City of Dublin

## **Basic Site Plan-Review**

### **16-015BSP– Penzone Grand Salon**

### **BSD Sawmill Center Neighborhood District**

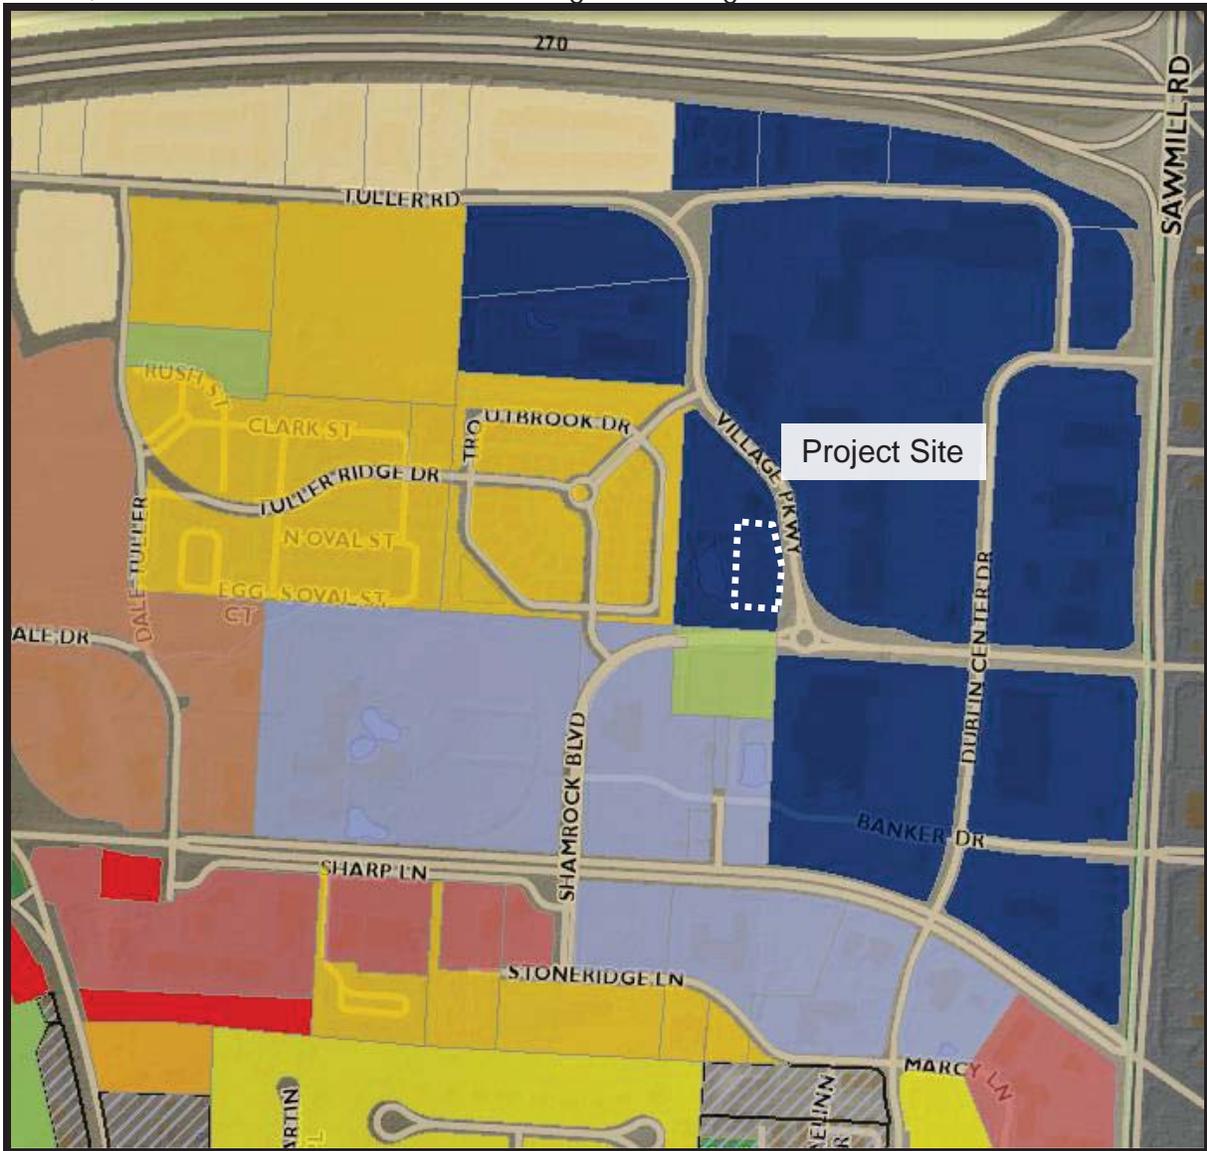
The project was reviewed by the Administrative Review Team (ART) on March 10, 2016 who expressed concerns about site layout, architecture and design, and parking. ART recommended the applicant bring the request to the Planning and Zoning Commission for an informal review to provide feedback on these elements.

The Commission informally reviewed and commented on this proposal on April 7, 2016. Many Commissioners were concerned that the proposal felt too suburban in the proposed location where an urban, walkable and energetic atmosphere is envisioned. The Commission complimented the applicant on the material selected for the proposed building, while also commenting on a lack of excitement for the building different from what is envisioned for the Bridge Street District. The Commission reiterated the district's vision for a dynamic, exciting entrance off Village Parkway for this area. The Commission encouraged the applicant to create opportunities with lighting, sophisticated site furnishings and elements to create space that

diminishes the parking lot presences in the site plan. The Commissioners discussed the location of right-of-way for a neighborhood street in relation to the existing driveway and structure.
